Hi-Fi Products
Service Bulletin

Model: D-180

No. 122

Subject: The Upper Lid Cannot Be Locked

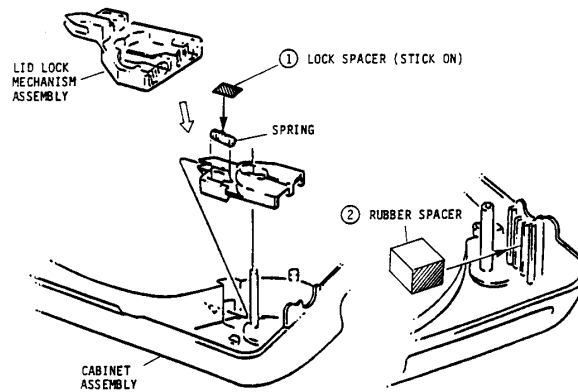
The spring for the upper lid lock mechanism shifts, and does not allow the upper lid to catch.

Solution: Add the two spacers shown below:

Ref. No.	Description	Part Number
①	Spacer, Lock	4-916-290-01
②	Spacer, Rubber	3-322-044-01
